Fw: CSXT LIRC Environmental Assessment

Subject: RE: CSXT LIRC Environmental Assessment

LIRC @ MP 66 - Abandoned Interurban RR @ west side.jpg

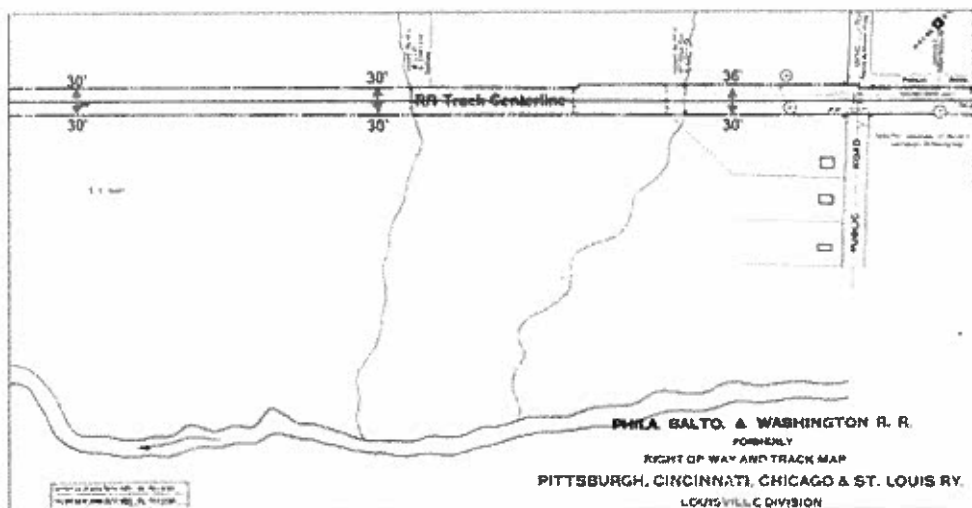
1. The first issue is the “second track” or “siding alongside”, and this is probably referencing the former Interurban RR ROW that apparently runs along the west side of LIRC in this area. – On the aerial below, you can see the shadow of the old RR ROW along the west side of the active RR. Having been onsite on much of this line, many physical aspects of this abandoned RR are still in place. – The Interurban was a passenger line that ran @ either side of the LIRC from Louisville all the way to Indianapolis, until it was abandoned in approx. 1940. – Much of the abandoned RR property went to the DOT for roads or the power company, where their pole

No this doesn't really answer my question - getting closer. There are two RR lines, if I assume the east line and add thirty feet that would be the eastern extent of the ROW?. However, could someone explain a 300 foot difference in this particular area of the line?

2. The second issue is “the 300’ difference”, and it seems this reference has lost its context. RR corridors are nearly always constructed with a centerline where the primary track is placed. A RR Valuation Map is a general survey for gov’t and real estate purposes, and the “Val Map” for the north end of the referenced area at County Road 50 N is shown below. Nearly all of this referenced 2-mile stretch has the RR track running down the center of the 60’ wide corridor, with 30’ of RR property on either side of the “RR Centerline”. But at the north end for approx. 300’, running south from County Road 50 N, the RR track is not in the center of RR property. There is 36’ measured out on the west side of the RR Centerline, and 30’ to the east. This is shown on the Valuation Map below.

The aerial below shows the two roads as found on Google Earth in relation to LIRC RR MP's, apparently @ approx. MP# 64 – MP# 66, between Seymour and Crothersville. – The Val Maps show the ROW here is 60' wide (30/30) from MP# 64-66, except for one area just south of MP# 64, along the west ROW line, where it's 36' wide on the west side of the RR CL, running south from CR 50 N for approx. 300'.
